Service Manual

Supplement

SL-P1200X

Note:
This supplement has been issued to inform you that the balanced output P.C.B. have been changed in units having serial number suffixes "Q" or later. (Refer to "How to read the serial number" shown at right.)

■ SCHEMATIC DIAGRAM

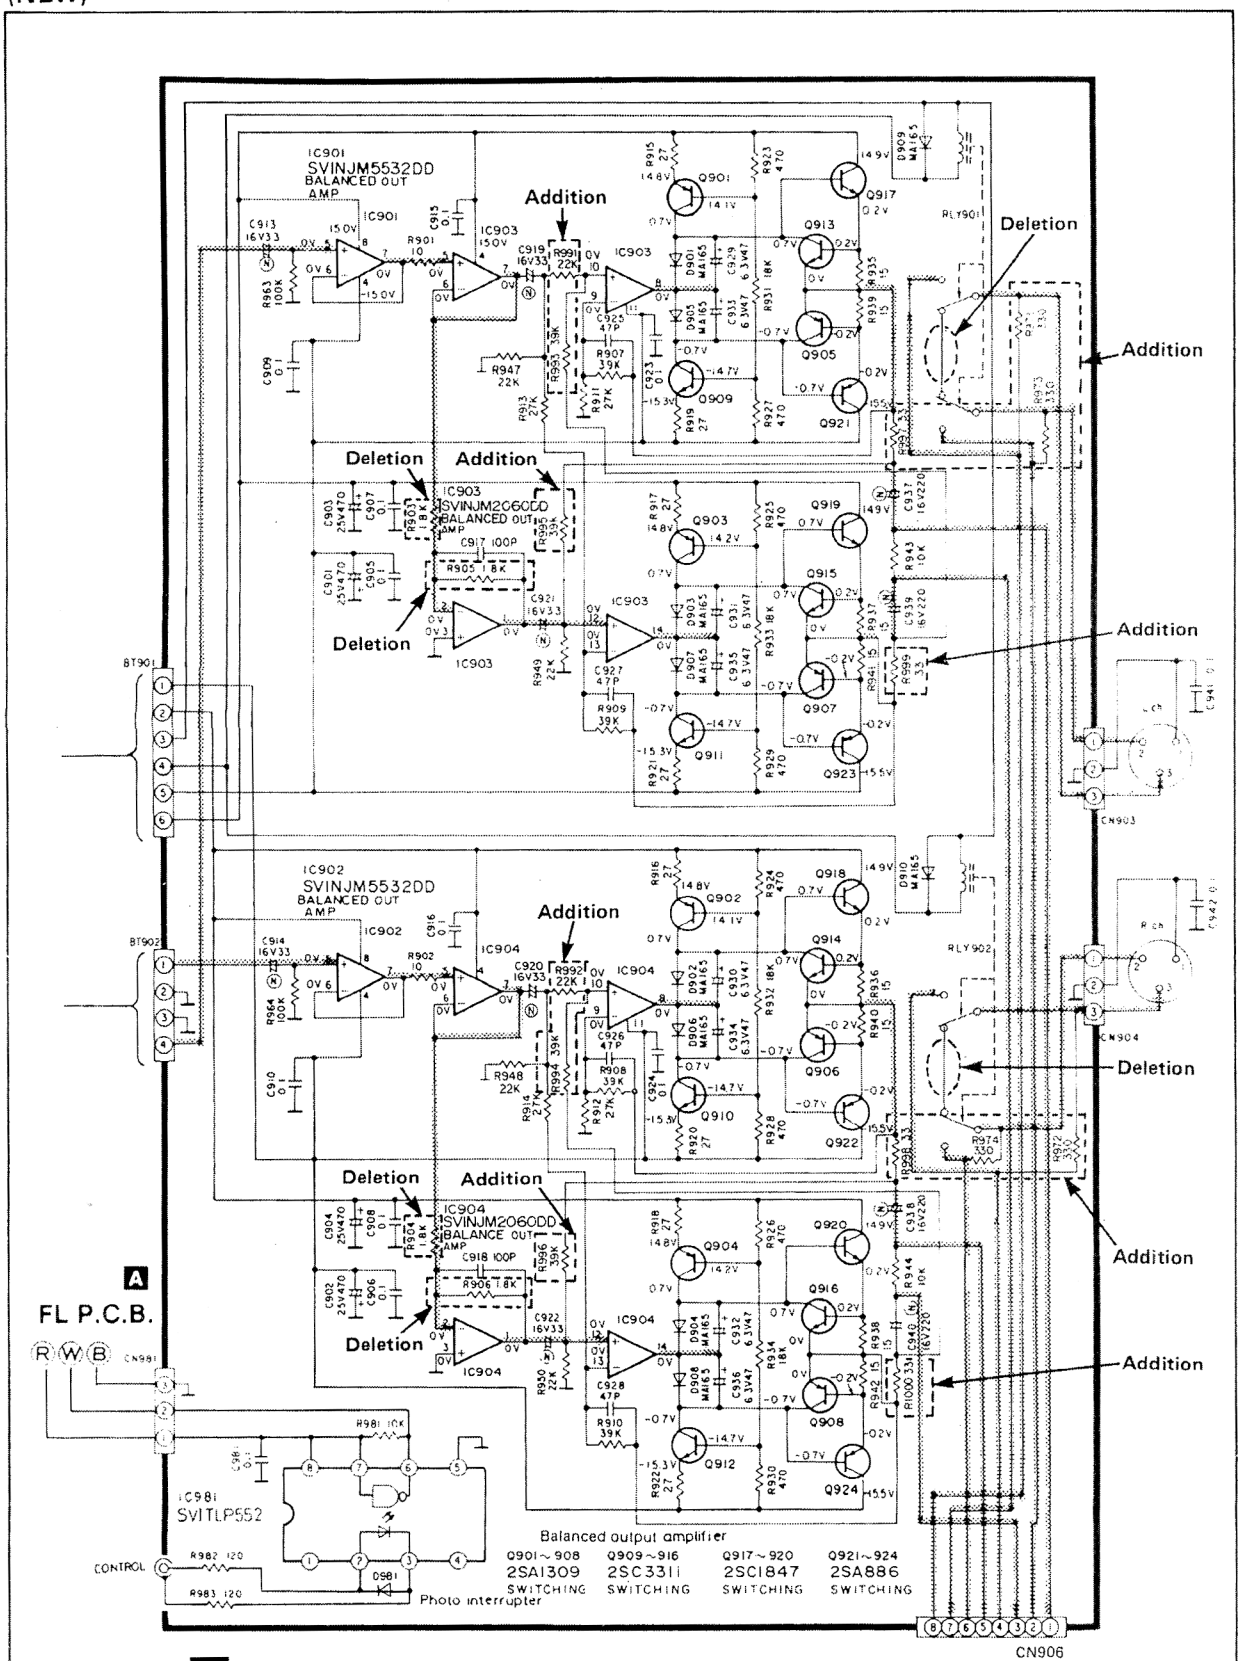
Ref. No.	Change of Part No. ORIGINAL → NEW		Description	Remarks
RESISTOR				
R903 ~ 906	ER0S2TKF1801	———	———	Deletion
R911 ~ 914	ER0S2TKF5602	**ER0S2TKF2702**	27KΩ, 1/4W	Change
R915 ~ 922	ERD25FJ150	**ERD25FJ270**	27Ω, 1/4W	Change
R935 ~ 942	ER0S2TKF8R20	**ER0S2TKF15R0**	15Ω, 1/4W	Change
R945, 946	ER0S2TKF6200	———	———	Deletion
R971 ~ 974	———	**ER0S2TKF3300**	330Ω, 1/4W	Addition
R991, 992	———	**ER0S2TKF2202**	22KΩ, 1/4W	Addition
R993 ~ 996	———	**ER0S2TKF3902**	39KΩ, 1/4W	Addition
R997 ~ 1000	———	**ER0S2TKF33R0**	33Ω, 1/4W	Addition
